**Proposed Temporary Warehouse (Excluding Dangerous Goods Godown) with Ancillary Facilities
and Associated Filling of Land for a Period of 3 Years in "Agriculture" Zone,
Various Lots in D.D. 107, Fung Kat Heung, Kam Tin North, Yuen Long, New Territories**

(S.16 Planning Application No. A/YL-KTN/1266)

Responses-to-Comments

(Application No. A/YL-KTN/1266)

For checking existing 800UC (Pavement ratio)

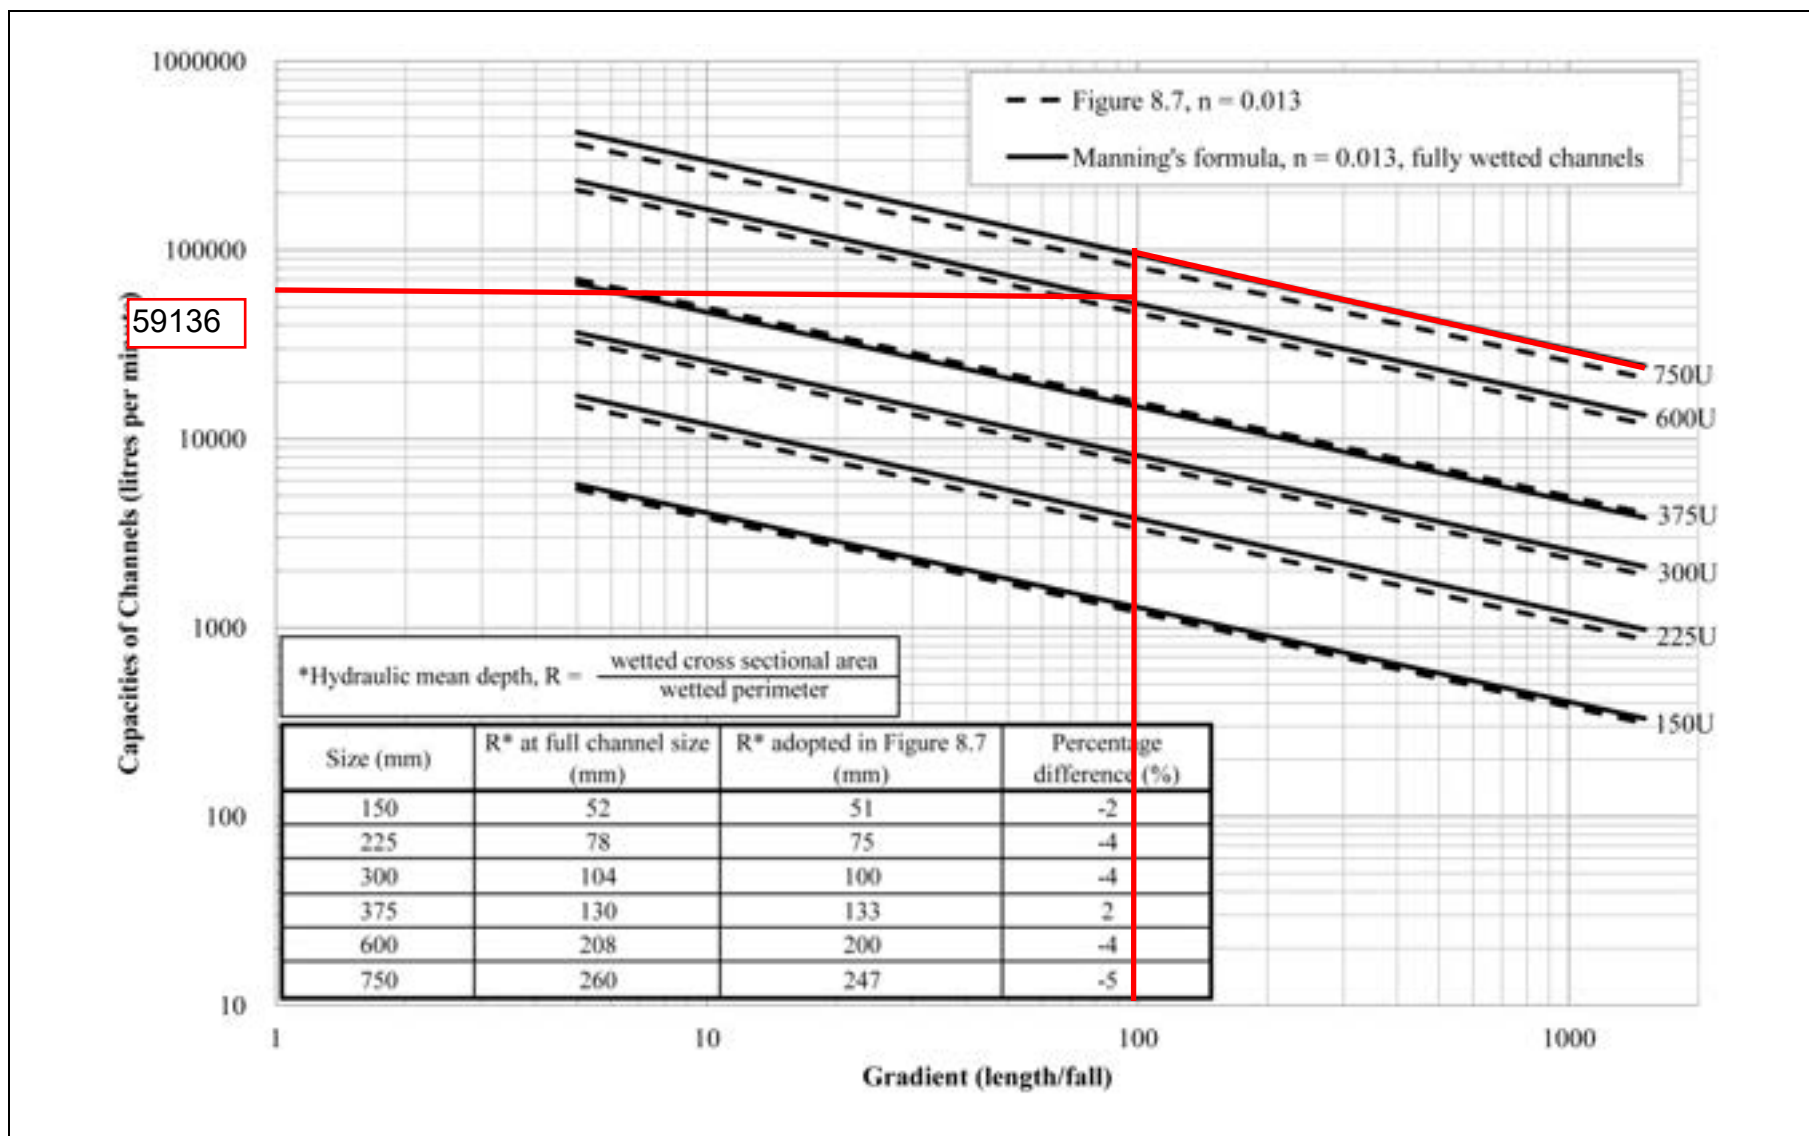
(A) Specific Comments		
(1)	For design checking of the existing drainage facilities, paved area assumed in the submitted hydraulic calculation is underestimated. The applicant should review paving ratio adopted in the submitted hydraulic calculation.	Noted. The paving ratio and paved area has been calculated. All hard-pave area is 7500 sqm ($7500/31112.2 = 0.3$) which is occupied one-third of catchment area (Appendix II).

All hard-pave area is 7500 sqm ($7500/31112.2 = 0.3$) which is occupied one-third of catchment area`

Total hard-paved area
= $800 \times 3 + 500 \times 5 + 1000 \times 2 + 750 + 600$
= 7500sqm

Legend: → Proposed UC (Gradient) with cast iron cover ⇌ Existing Drain □ Proposed Catchpit	
Company:	
Project: Various Lots in D.D. 107, Fung Kat Heung, Kam Tin, Yuen Long, New Territories (A/YL-KTN/1266) (Drainage Proposal)	
Title: Eye Location Plan	
Dwg No: Fig.6	File:
Date: 8 May 2025

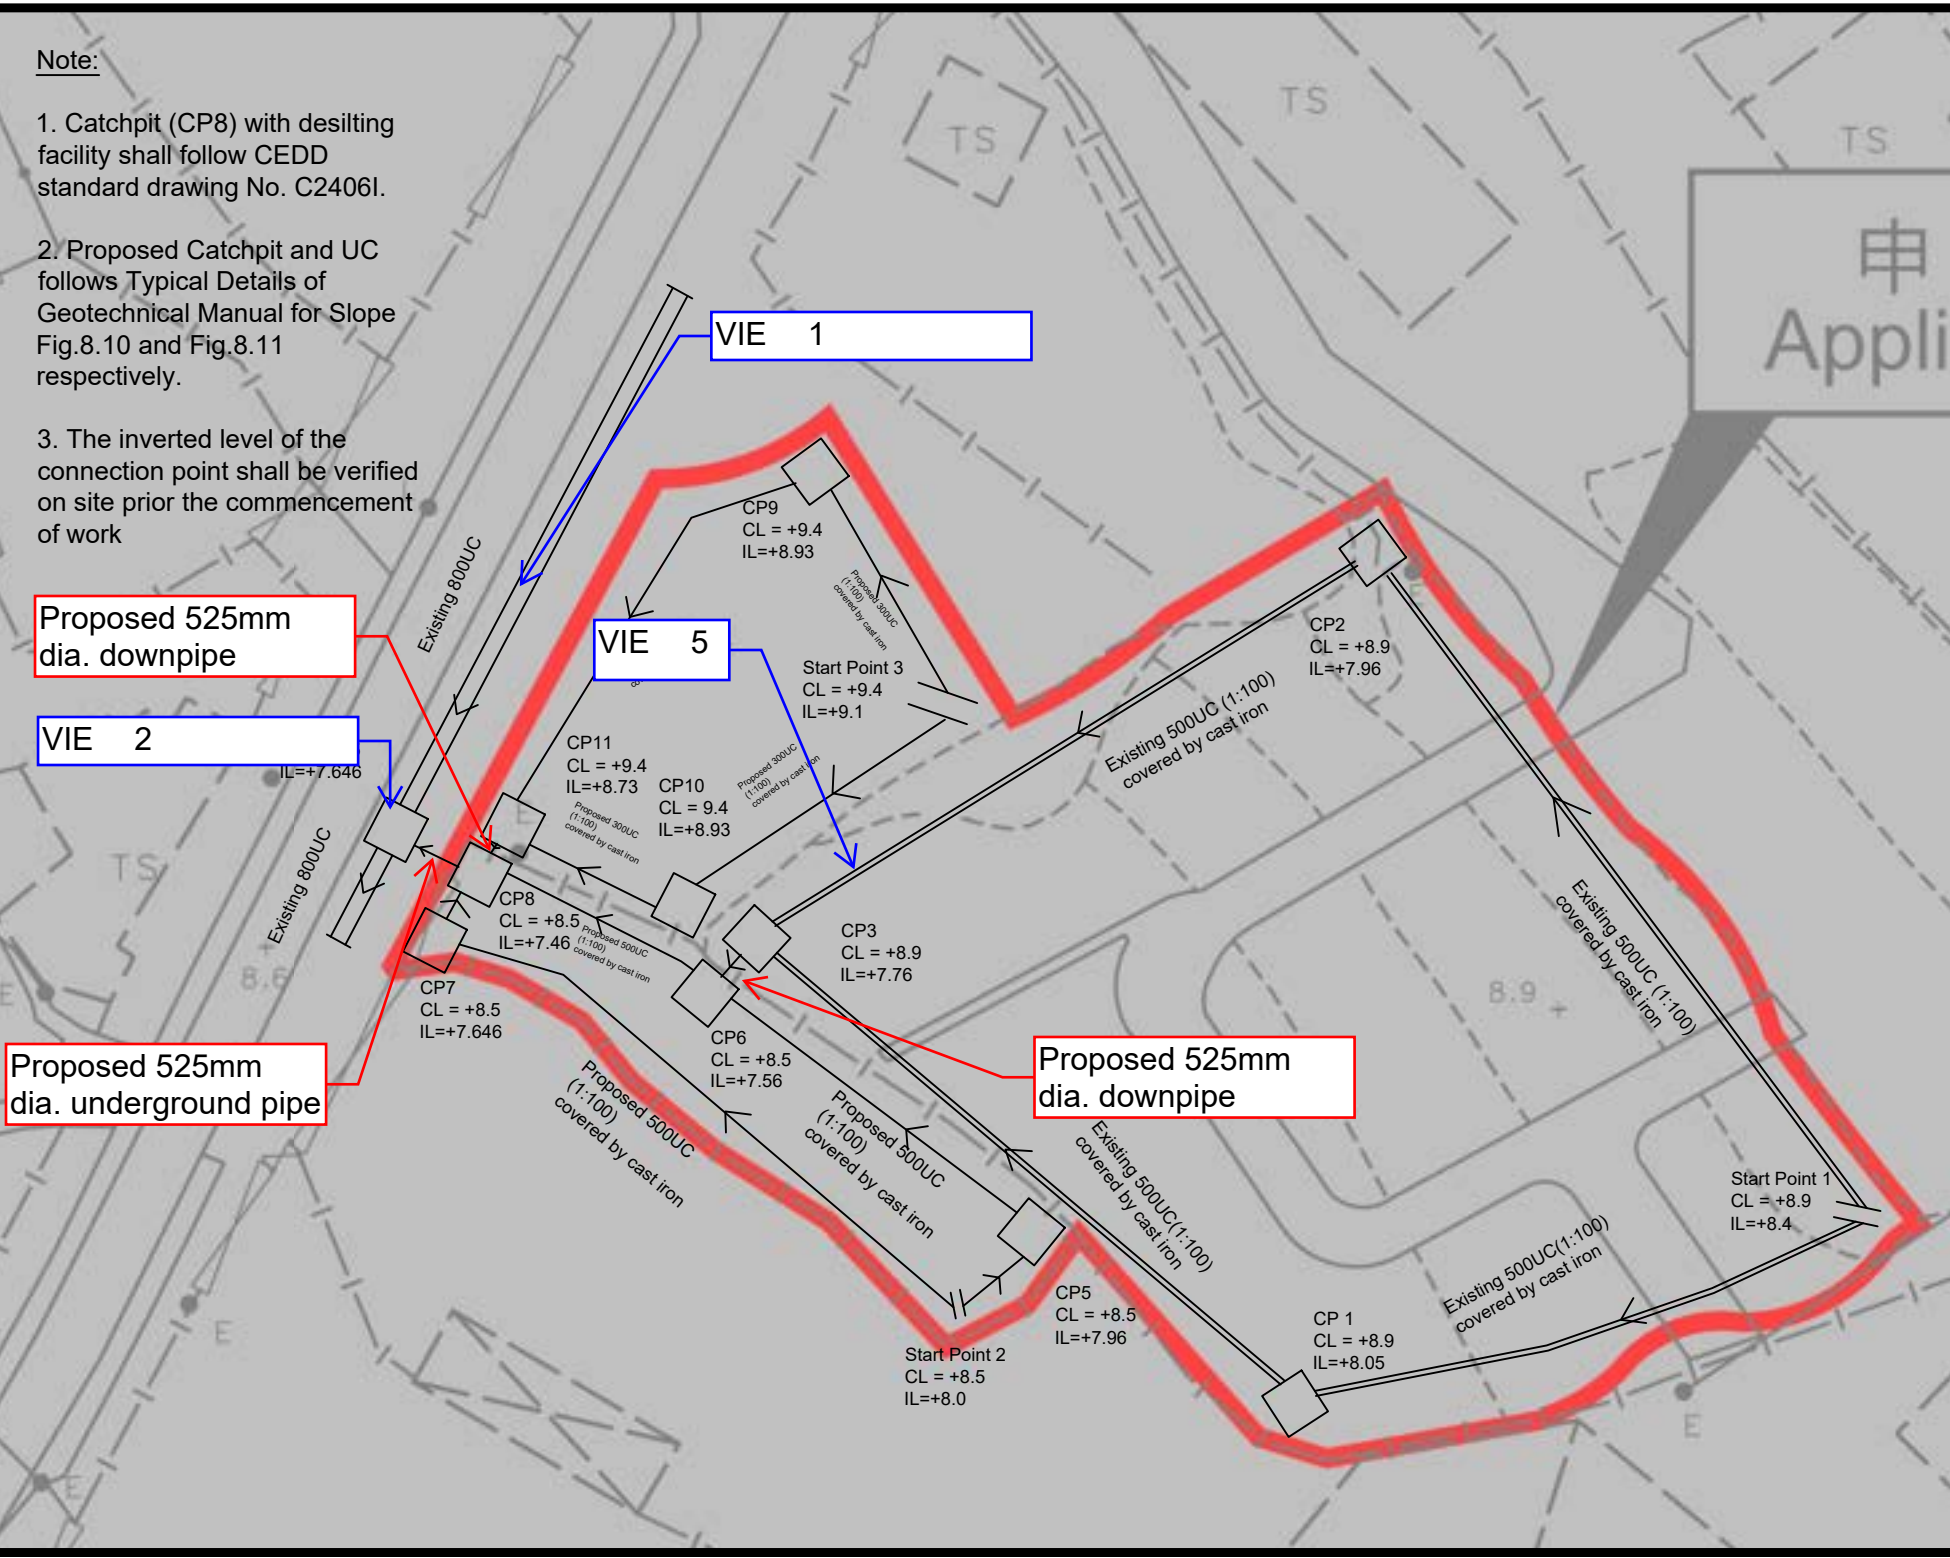
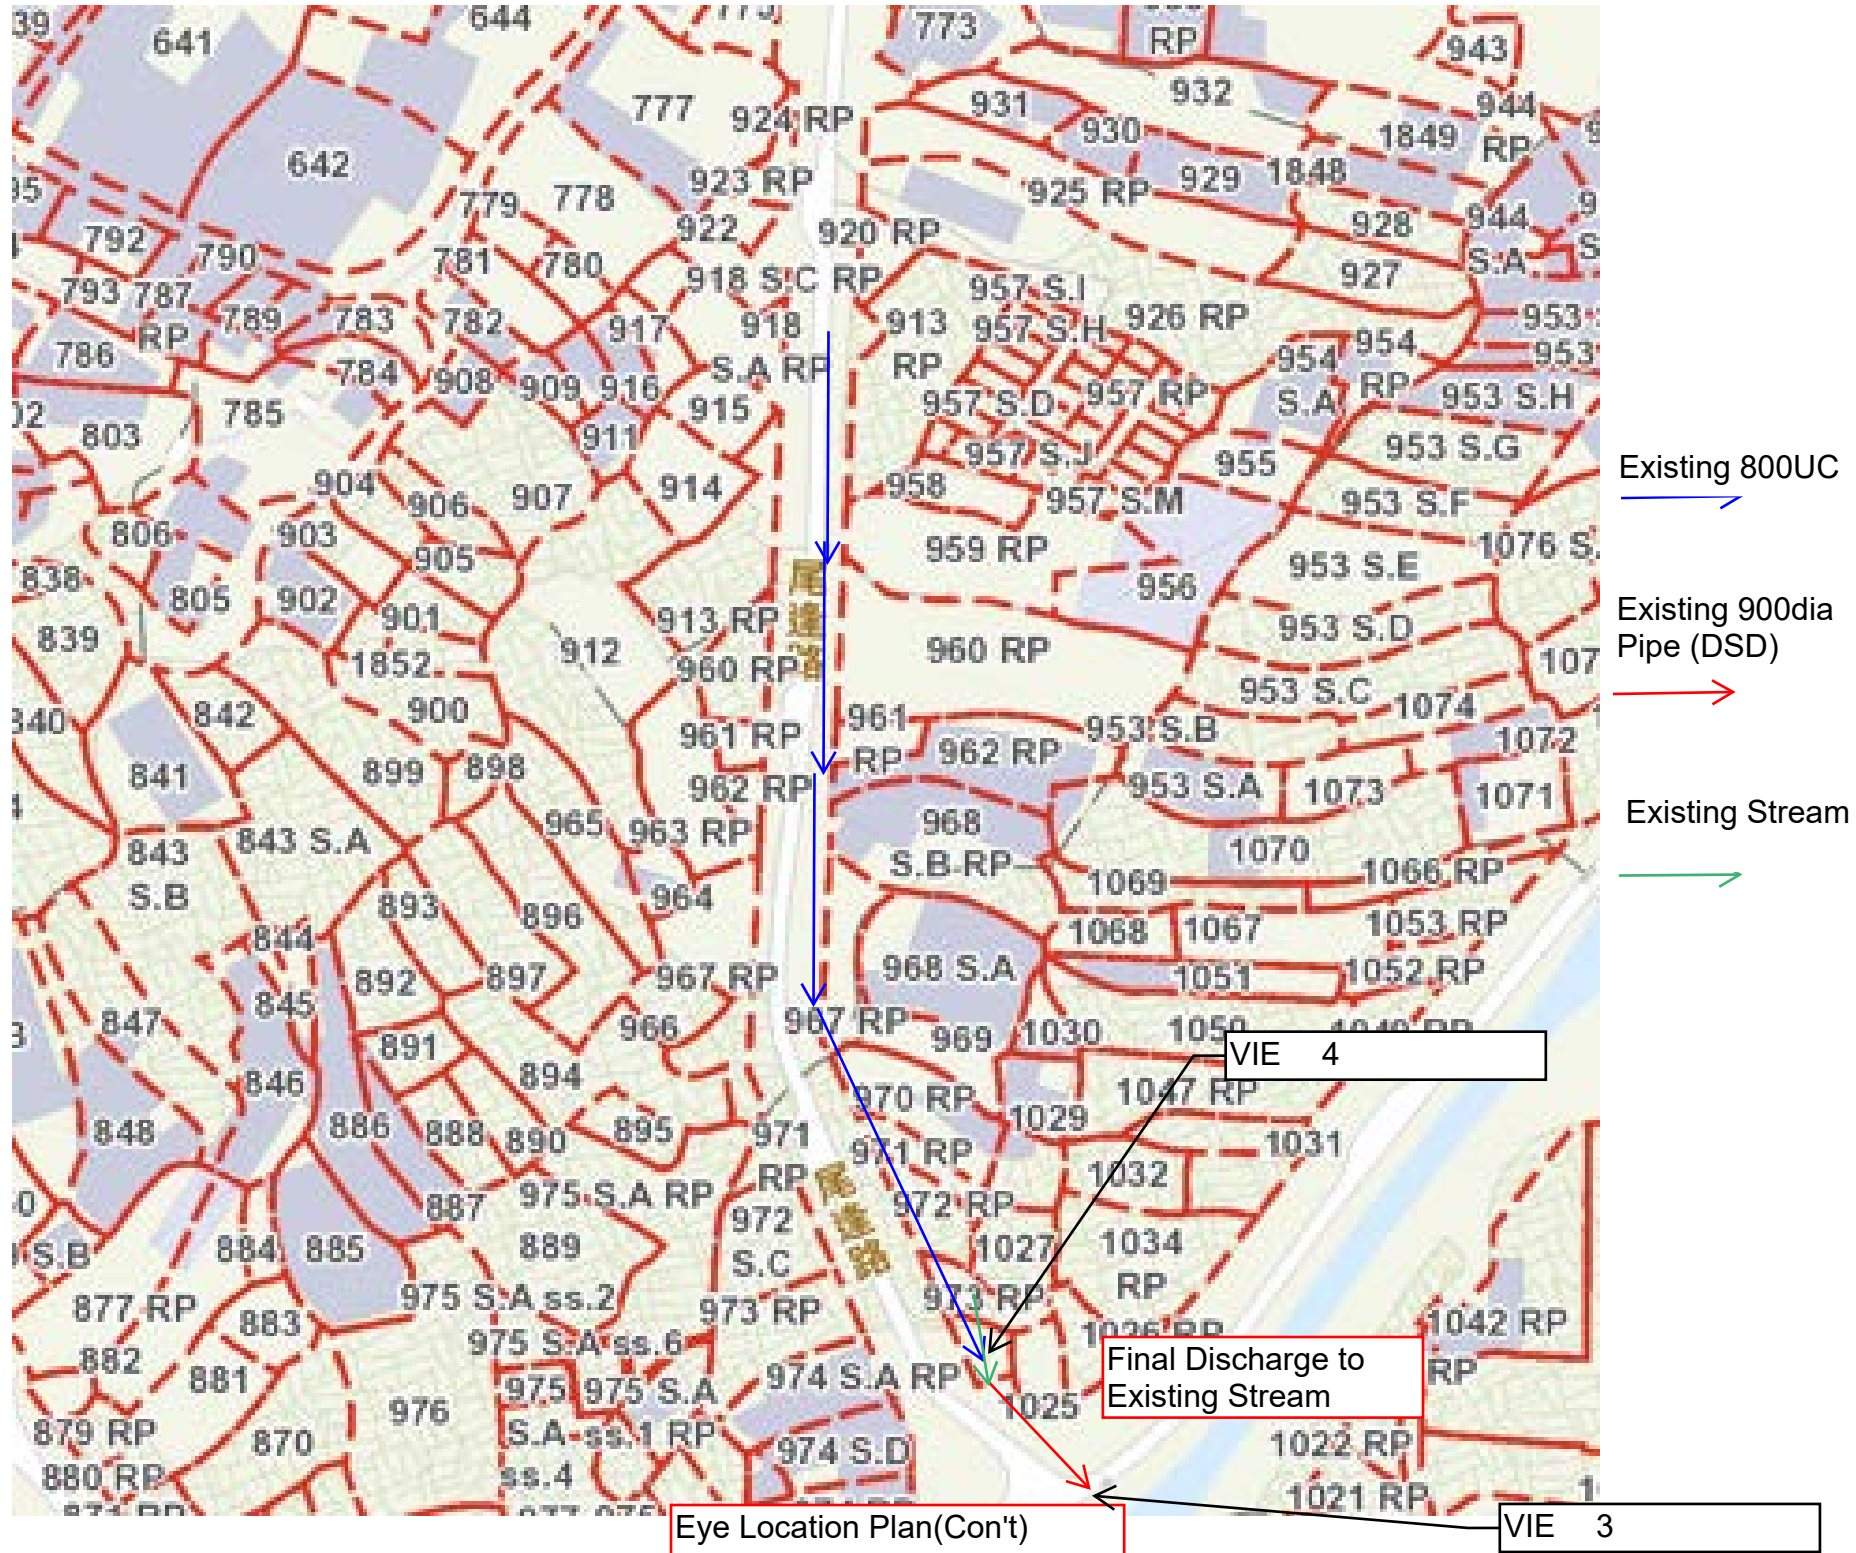
(3)	The applicant should provide site photos to demonstrate size of the existing surface channel mentioned in the proposal. Also, the applicant should provide site photos to show the connection of the existing 800 mm (W) surface channel and 900 mm dia. storm water pipe mentioned in the proposal.	Site photos have been demonstrate size of the existing surface channel mentioned in the proposal. Also, we have provide site photos to show the connection of the existing 800 mm (W) surface channel and 900 mm dia. stormwater pipe mentioned in the proposal (Appendix II).

VIE 1: Existing 800UC

VIE 2: Existing 800UC (Connection)

VIE 3: Existing 900mm dia. underground pipe

VIE 4: Connection Existing 900mm dia. underground pipe and Existing 800UC
